Subject: Class 3 Permit Modification Request, Construction and Use of Hazardous Waste Disposal Units 11 and 12 for the Waste Isolation Pilot Plant Hazardous Waste Facility Permit Number: NM4890139088-TSDF

**Class 3 Permit Modification Request**

**Construction and Use of Hazardous Waste Disposal Units 11 and 12**

**Waste Isolation Pilot Plant  
Carlsbad, New Mexico**

**Figure A4-4b**  
**Typical Underground Transport Route Using S-700 or S-850**

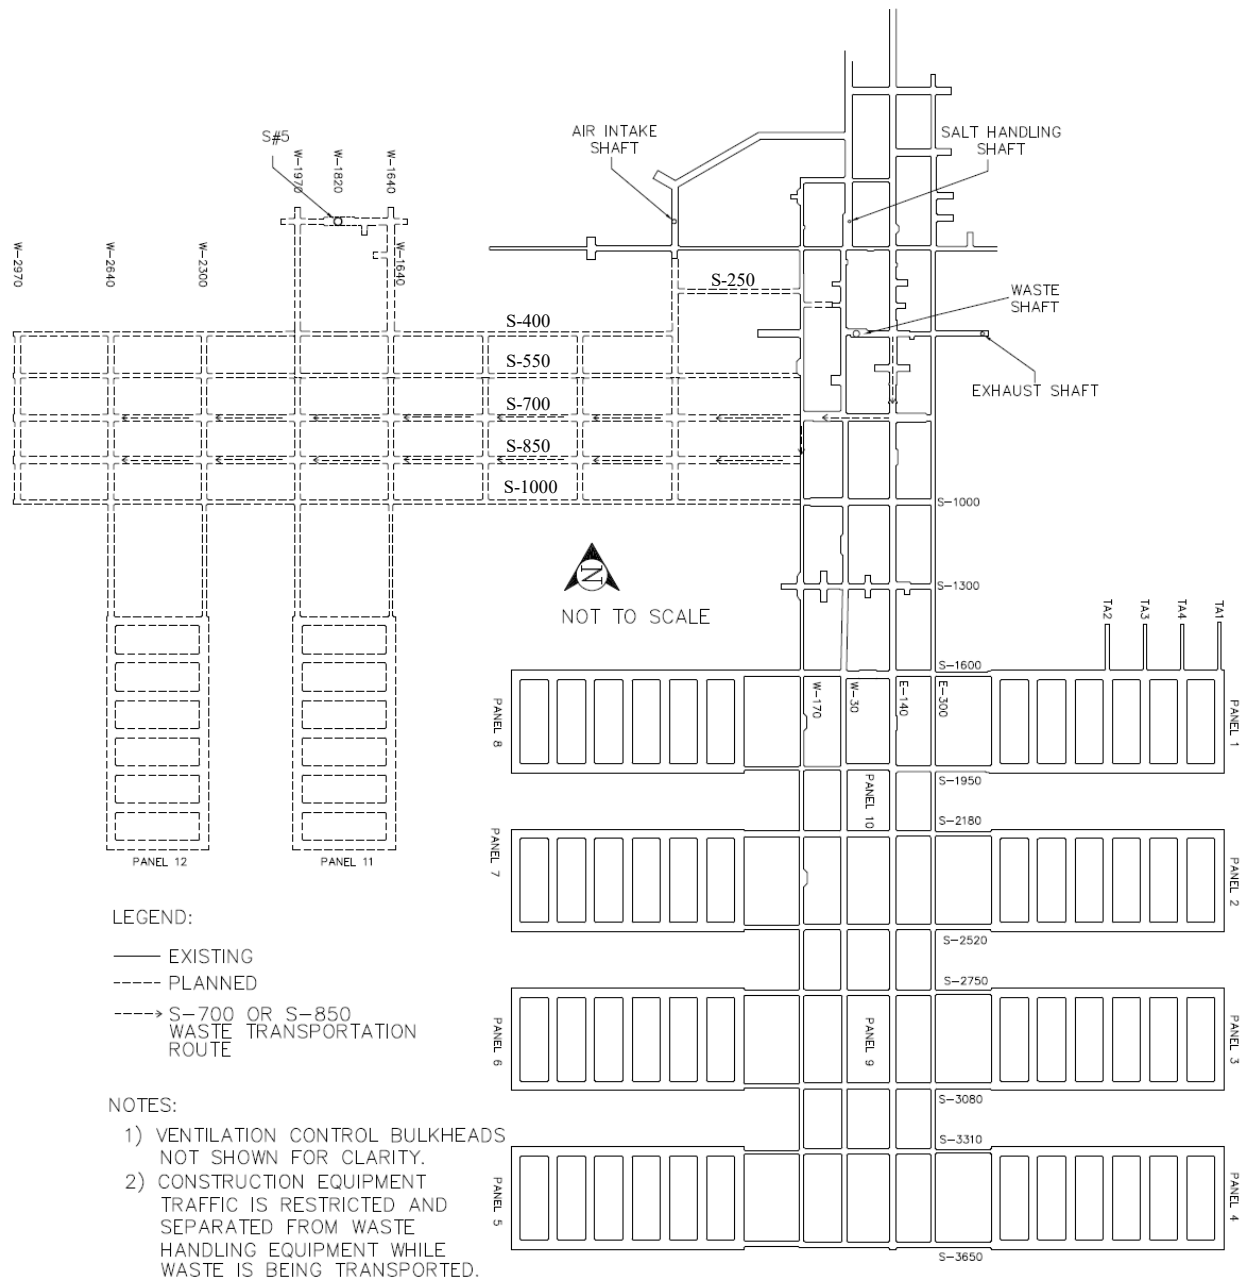
- Permit Attachment A4, Figure A4-4b, *Typical Underground Transport Route using S-700 or S-850*, is being added to show the waste transport routes for Panels 11 and 12. Additionally the *List of Figures* is being modified to include Figure A4-4b. Figures A4-4, *Typical Underground Transport Route Using E-140*, and A4-4a, *Typical Underground Transport Route Using W-30*, are being modified to show the proposed West Mains and Panels 11 and 12 in order to ensure accuracy of the figures.

| Permit Part/Section                              | Impact  |
|--|---|
| Attachment A4, Figures                           | Added a new figure, Figure A4-4b, <i>Typical Underground Transportation Route Using S-700 or S-850</i> to show the planned transport route for waste to Panels 11 and 12. This figure is needed to show the planned waste transport routes in the West Mains.   |

| Affected Permit Section                                 | Explanation of Change   |
|---|---|
| Attachment A4, Figures                                  | Added a new Figure A4-4b to show the proposed waste transport routes in S-700 or S-850 of the West Mains.   |

**Figure B3-1**  
**Spatial View of the WIPP Facility**

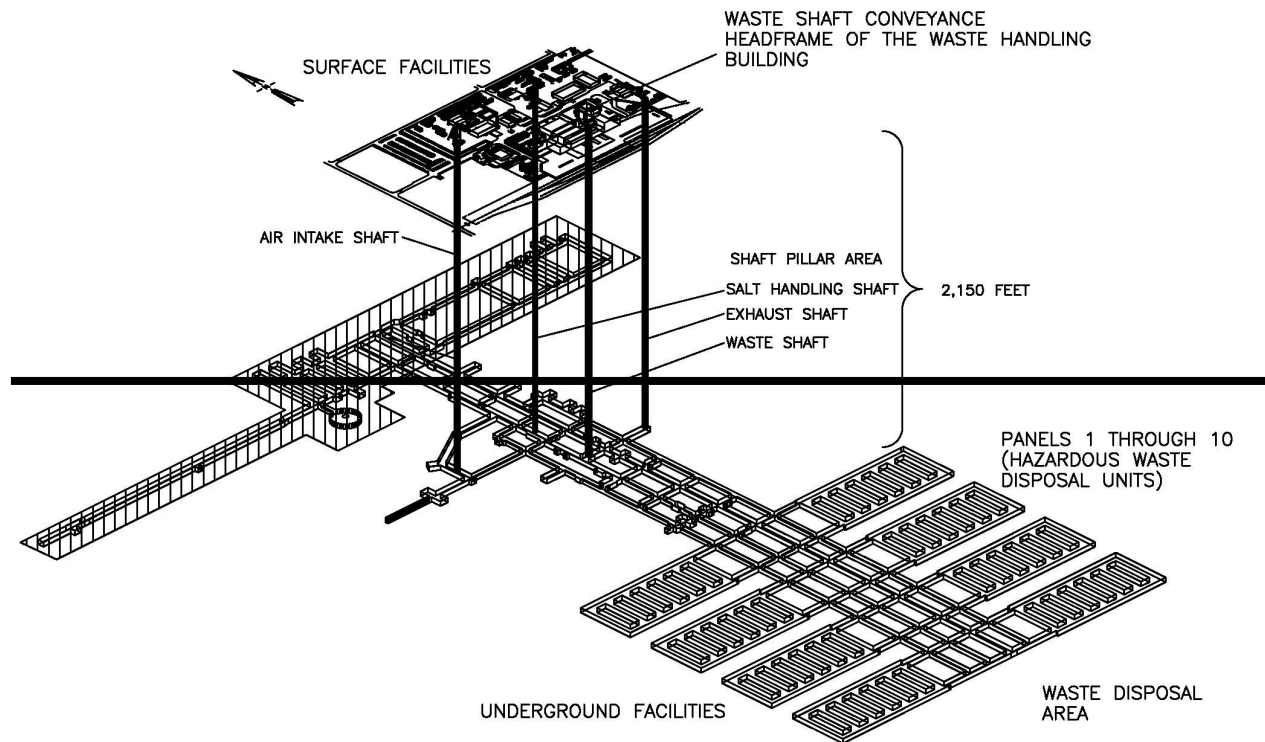
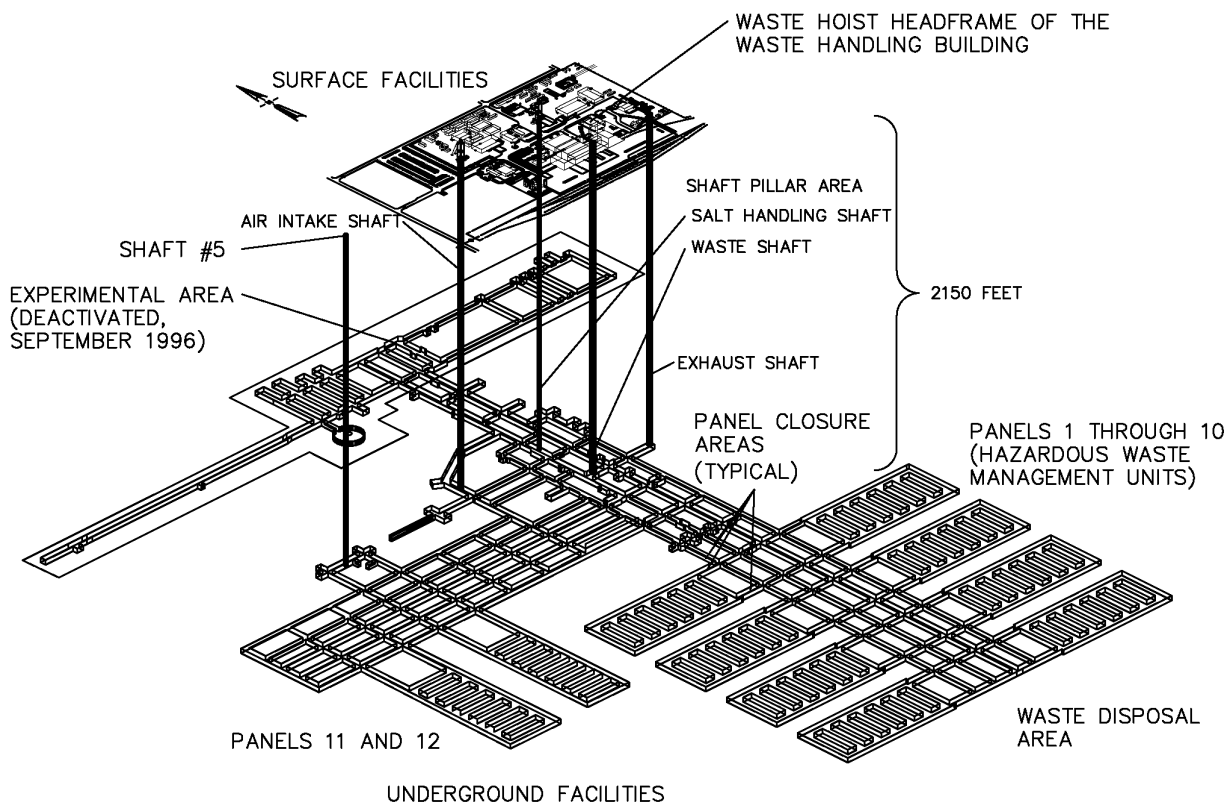
- Permit Attachment B, Appendix B3, Figure B3-1, *Spatial View of the WIPP Facility*, is being modified to include the West Mains and Panels 11 and 12.

| Permit Part/Section                              | Impact  |
|--|---|
| Attachment B, Appendix B3                        | Modified Figure B3-1, <i>Spatial View of the WIPP Facility</i> , to accurately show the West Mains and Panels 11 and 12. This modification is needed to accurately show the planned underground repository.   |

| Affected Permit Section                                 | Explanation of Change   |
|---|---|
| Attachment B, Appendix B3, Figure B3-1                  | Replaced figure to include the West Mains and Panels 11 and 12.   |

**Figure B3-2**  
**Repository Horizon**

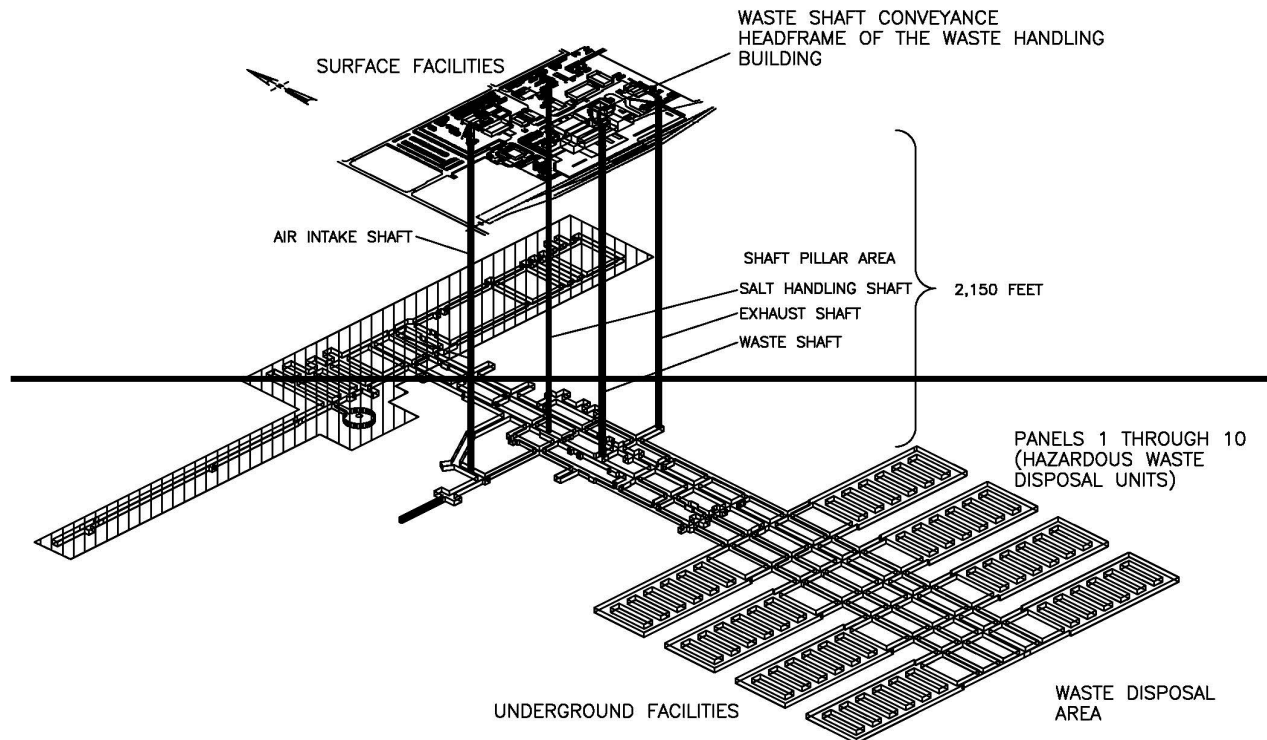
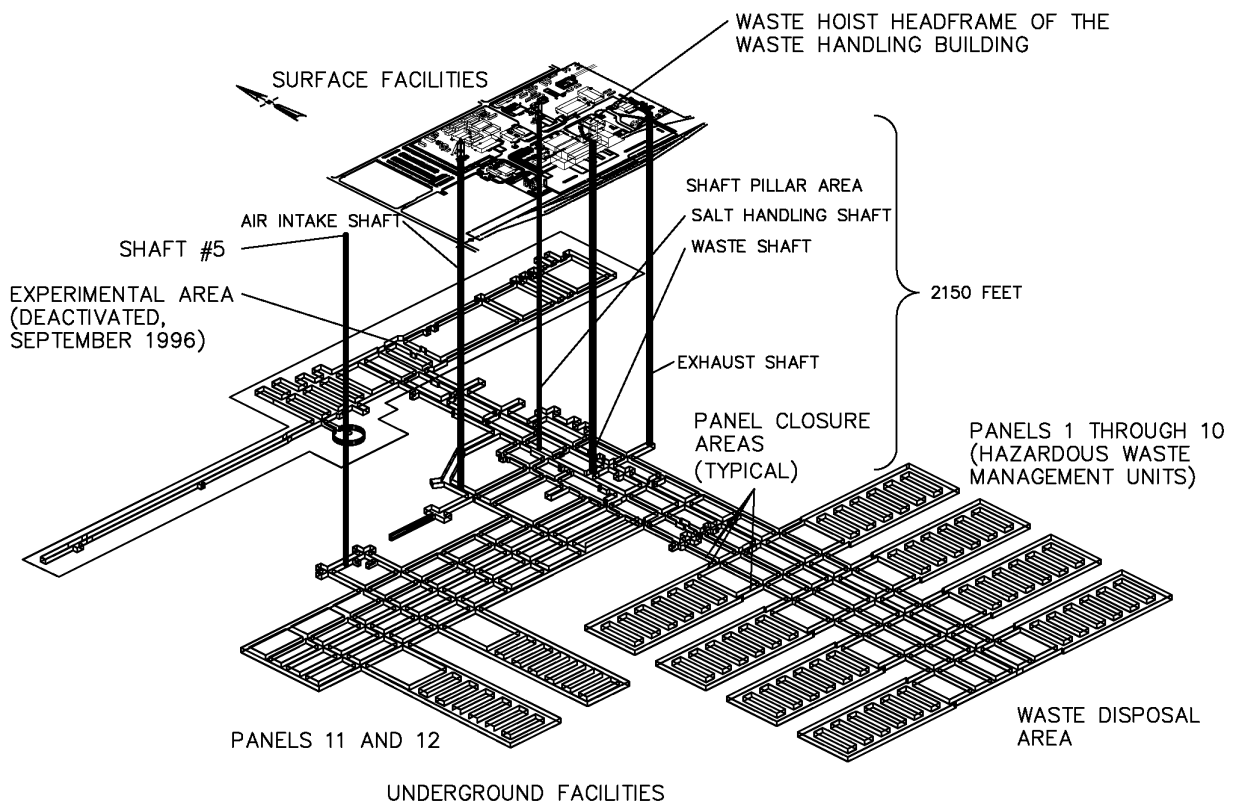
- Permit Attachment B, Appendix B3, Figure B3-2, *Repository Horizon*, is being modified to include the West Mains and Panels 11 and 12.

| Permit Part/Section                              | Impact  |
|--|---|
| Attachment B, Appendix B3                        | Modified Figure B3-2, <i>Repository Horizon</i> , to accurately show the West Mains and Panels 11 and 12. This modification is needed to accurately show the planned underground repository.  |

| Affected Permit Section                                 | Explanation of Change   |
|---|---|
| Attachment B, Appendix B3, Figure B3-2                  | Replaced figure to include the West Mains and Panels 11 and 12.   |

**Figure D-2**  
**Spatial View of the WIPP Facility**

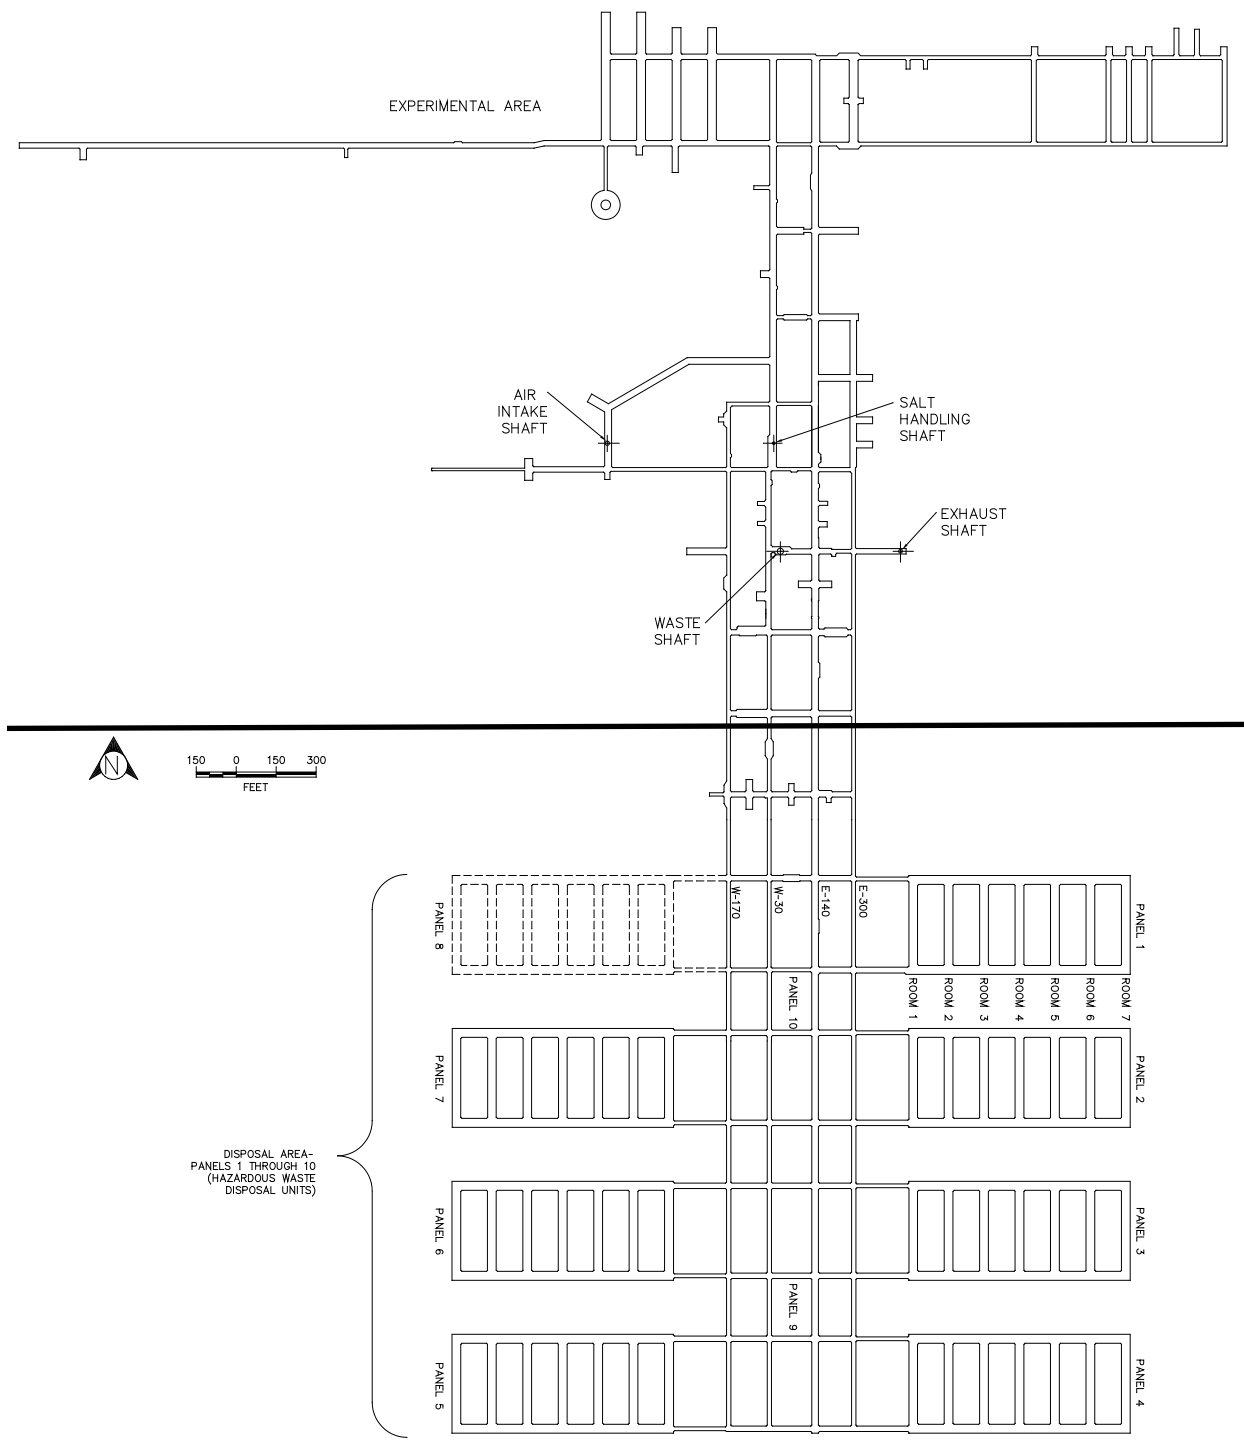
| Permit Part/Section                              | Impact  |
|--|---|
| Attachment D, Figures                            | Modified Figure D-2, <i>Spatial View of the WIPP Facility</i> , to show the planned underground repository layout with the West Mains and Panels 11 and 12. This modification is needed to accurately depict the planned underground repository layout.   |

| Affected Permit Section                                 | Explanation of Change   |
|---|---|
| Attachment D, Figure D-2                                | Replaced figure to show the West Mains and Panels 11 and 12 in the spatial view of the WIPP facility.   |

**Figure D-3**  
**WIPP Underground Facilities**

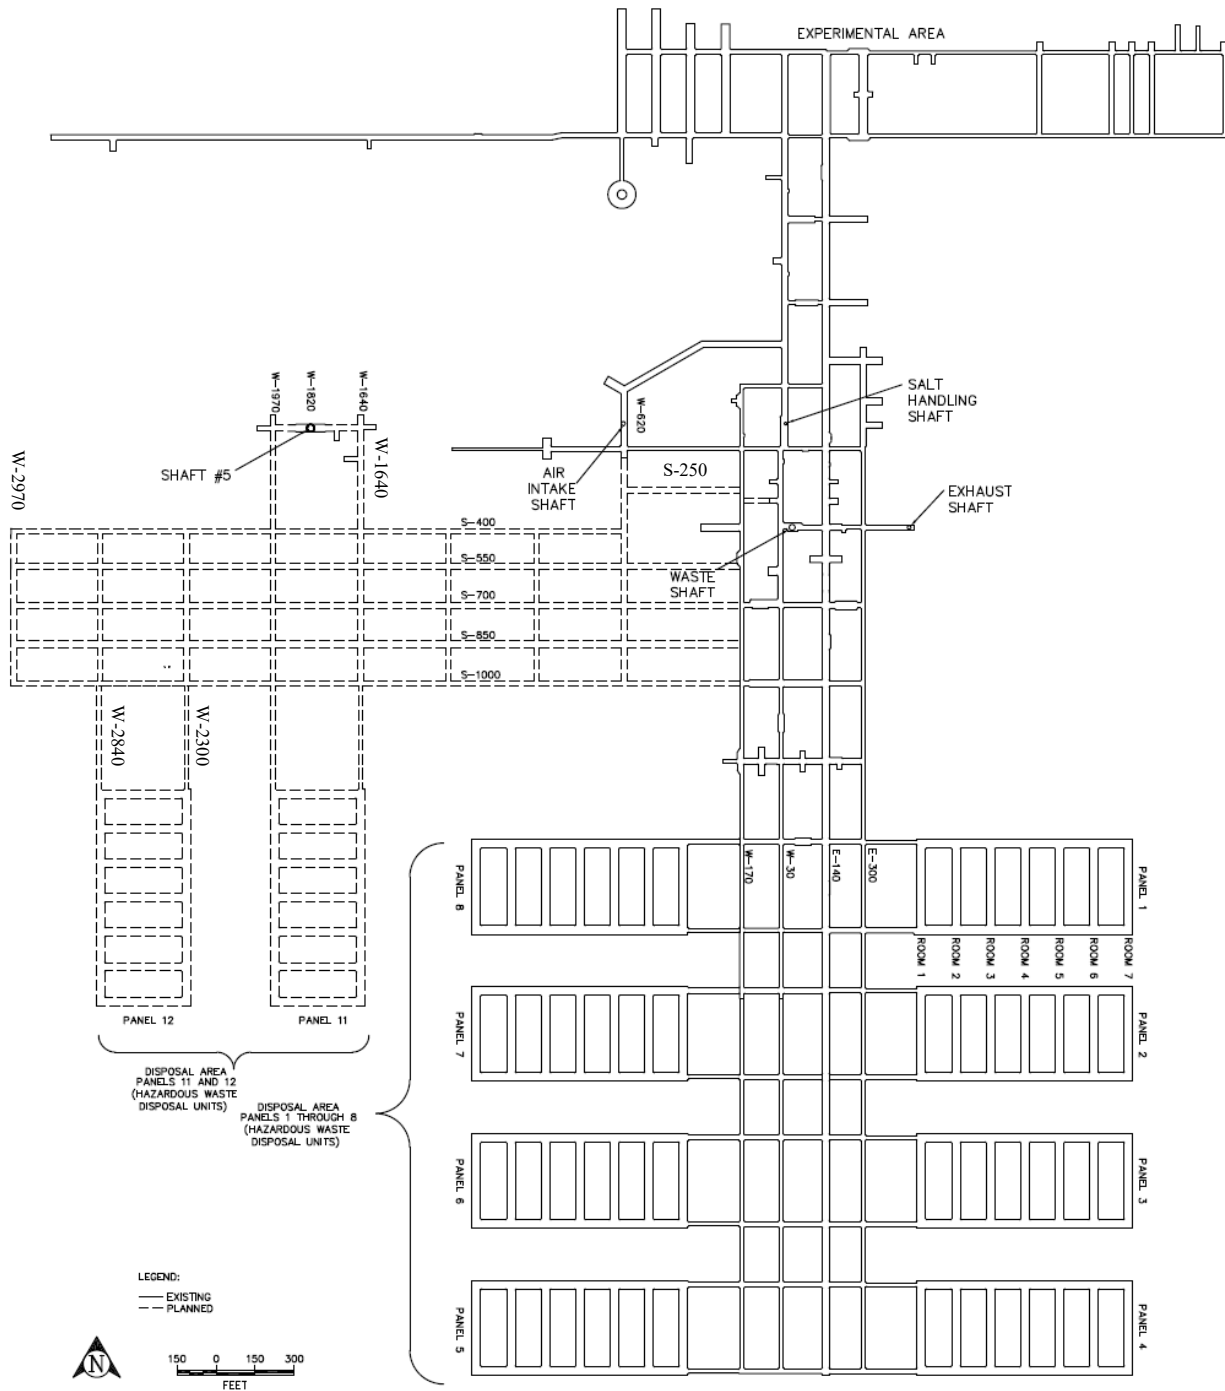
| Permit Part/Section                              | Impact  |
|--|---|
| Attachment D, Figures                            | Modified Figure D-3, <i>WIPP Underground Facilities</i> , to show the planned underground repository layout with the West Mains and Panels 11 and 12. This modification is needed to accurately depict the planned underground repository layout.   |

| Affected Permit Section                                 | Explanation of Change   |
|---|---|
| Attachment D, Figure D-3                                | Replaced figure to show the West Mains and Panels 11 and 12 in the plan view of the underground facilities.   |
